# UNITED STATES PATENT AND TRADEMARK OFFICE

10/586,972

<b>Office Action Summary</b>	<b>Application No.</b> 10/586,972	<b>Applicant(s)</b> MARISSSEN ET AL.	
	<b>Examiner</b> JAN CHRISTOPHER MERENE	<b>Art Unit</b> 3733

## **DETAILED ACTION**

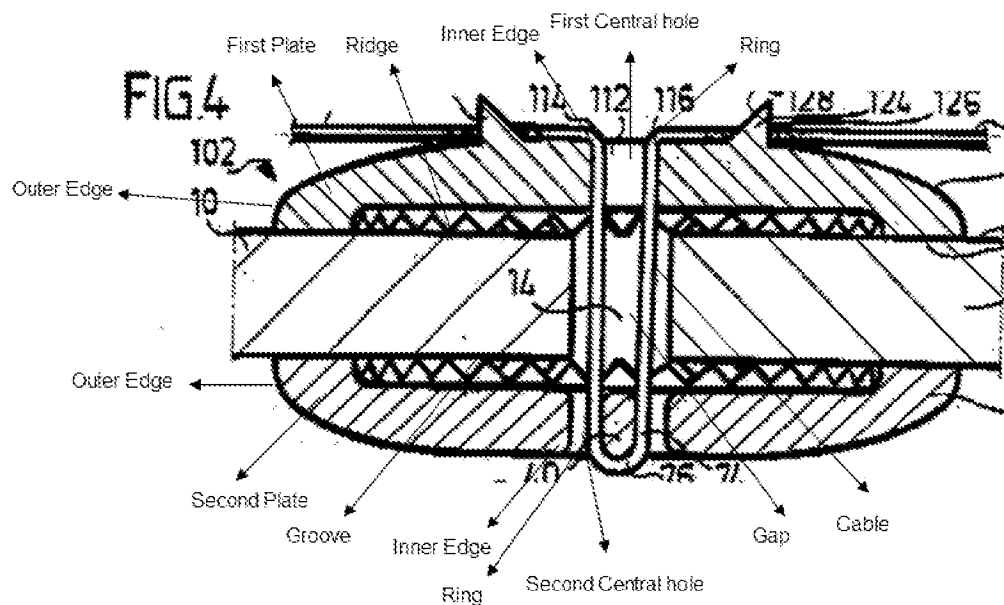
Regarding **Claim 1**, Nesper discloses a fixing device (as seen in Fig below) comprising:

a surgical cable having a first and a second end and (see fig below and paragraph 55)

at least a first and a second fixing plate each having a first and second central hole respectfully (as seen in Fig below and paragraph 47) and

a first and second ring surrounding said first and second hole respectfully (as seen in Fig below and paragraph 71),

the circumference of each fixing plate forming an outer edge of its ring and an inner edge of its ring being adjacent to the hole it surrounds (as seen in Fig below and ,

the first fixing plate being in a stacked position on top of the second plate leaving a gap between the plates and the holes at least partly overlapping each other (as seen in Fig below),

wherein in the ring of one of the fixing plates in its surface facing the other fixing plate a continuous groove is present running between the outer edge and the inner edge of said ring and in the ring of the other fixing plate in its surface facing the one of the fixing plates a ridge is present matching with said groove (as seen in Fig below and paragraph 51), and

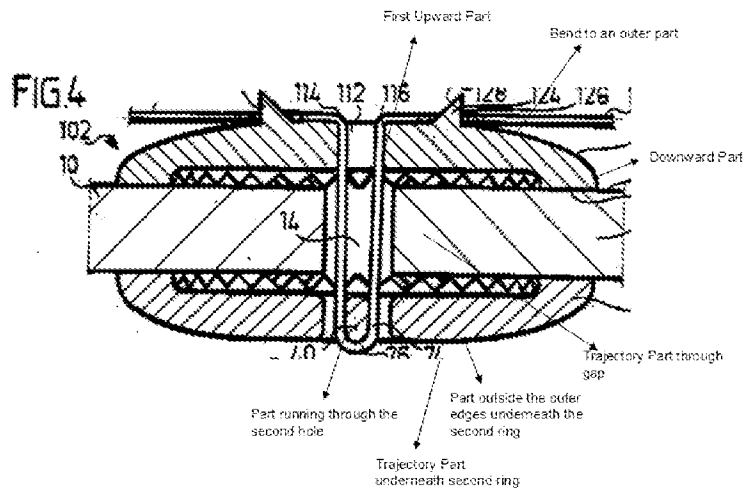
wherein at least one end of the cable following a continuous trajectory running as part from outside the outer edges underneath the second ring up to the second hole, bending upward into a first upward part running through the second and the first holes, a bend to an outward part running across the first ring in the direction of its outer edge, a downward part outside said outer edge running in a direction opposite to the upward part, a part running through the hole of the second ring, part at its one end being

connected to a trajectory part running through the gap between the fixing plates and at its other end being connected to a trajectory part running underneath the second ring, the other end of the cable also being connected to the fixing plates (see Fig below and paragraph 55, where one can place the cable in any number of configurations such as that listed above, if one chooses to do so).

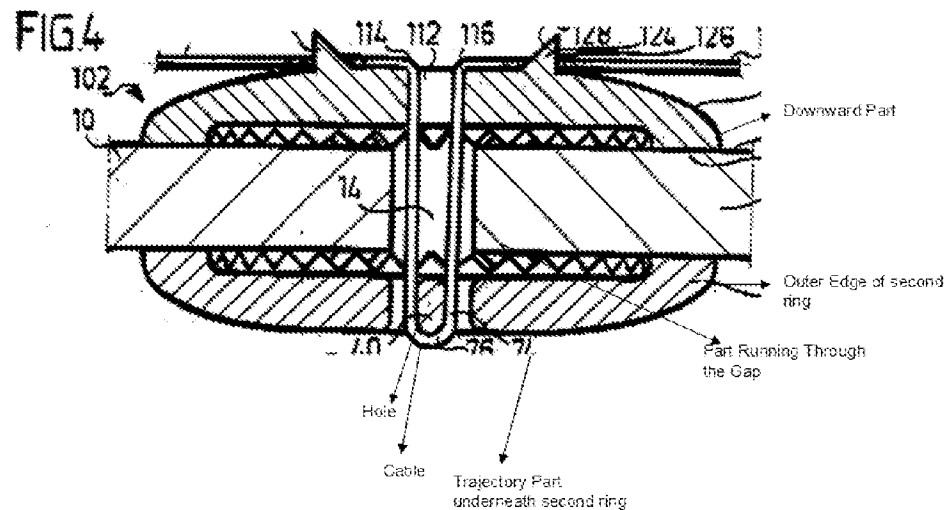
Regarding **Claim 2**, Nesper discloses wherein part further runs outside the outer edge of the second ring and is connected to one end of part through trajectory part running underneath the second ring from its outer edge to its hole and the other end of part is immediately connected to part running through the gap between the fixing plates in an outward direction and ending outside the plates in a cable end (see Fig below and above in claim 1 and the examiner notes that one can place the cable in any number of configurations such as that listed above and in claim 1, if one chooses to do so).

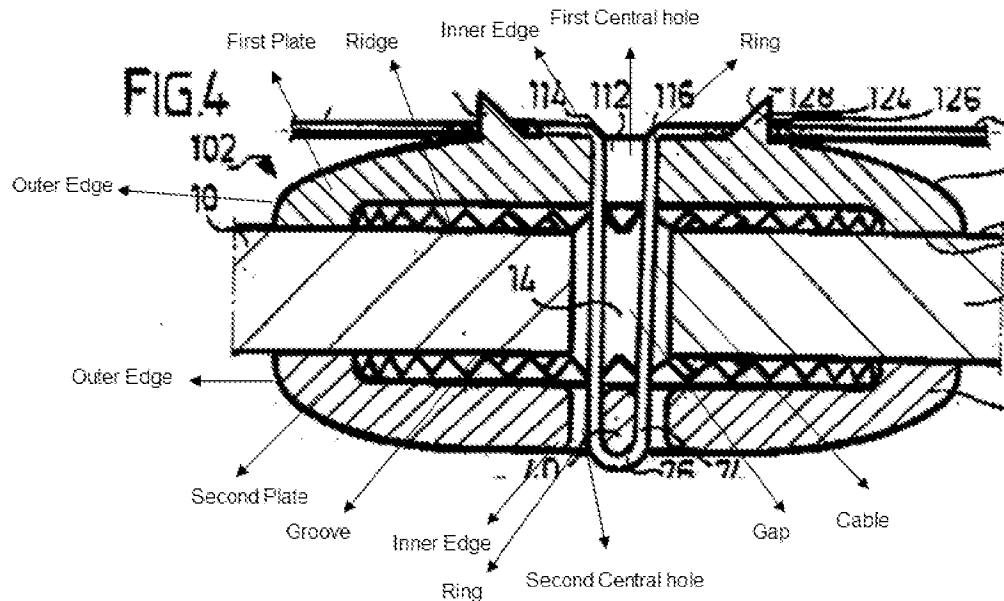
Regarding **Claim 4**, Nesper discloses wherein the cable can be connected to first upward part and the part underneath the second ring through an additional complete loop, beginning at the end of, running in an upward direction through holes and, then in an outward direction across the first ring, then in a downward direction along outer edges, then in an inward direction underneath the second ring and finally connecting to trajectory (see Fig above in claim 1 and 2, the examiner notes that one can place the cable in any number of configurations such as that listed above and in claim 1, if one chooses to do so).

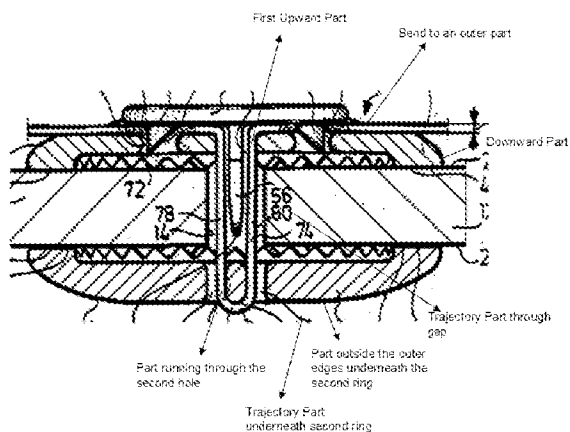
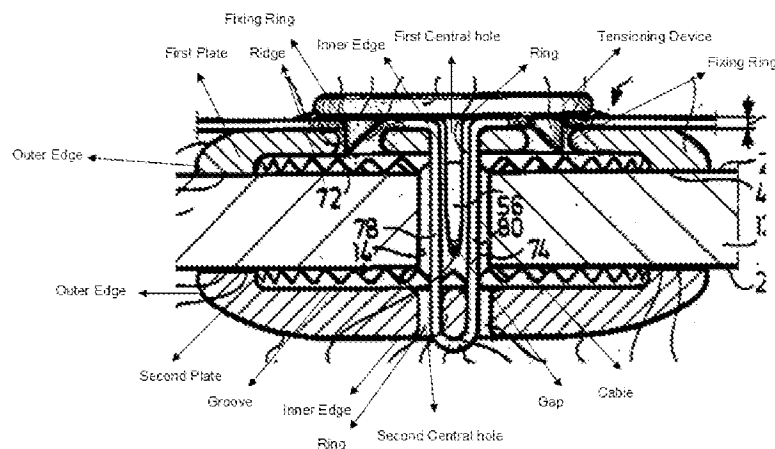
Regarding **Claims 1, 6**, Nesper discloses a fixing device (as seen in Fig below) comprising:

a surgical cable having a first and a second end and (see fig below and paragraph 55)

at least a first and a second fixing plate each having a first and second central hole respectfully (as seen in Fig below and paragraph 47) and

a first and second ring surrounding said first and second hole respectfully (as seen in Fig below and paragraph 71),

the circumference of each fixing plate forming an outer edge of its ring and an inner edge of its ring being adjacent to the hole it surrounds (as seen in Fig below and ,

the first fixing plate being in a stacked position on top of the second plate leaving a gap between the plates and the holes at least partly overlapping each other (as seen in Fig below),

wherein in the ring of one of the fixing plates in its surface facing the other fixing plate a continuous groove is present running between the outer edge and the inner edge of said ring and in the ring of the other fixing plate in its surface facing the one of the fixing plates a ridge is present matching with said groove (as seen in Fig below and paragraph 51), and

connected to a trajectory part running through the gap between the fixing plates and at its other end being connected to a trajectory part running underneath the second ring, the other end of the cable also being connected to the fixing plates (see Fig below and paragraph 55, where one can place the cable in any number of configurations such as that listed above, if one chooses to do so), wherein the other end is fixed to a tensioning device (#50) that is connected to the fixing rings (as seen in Fig below).
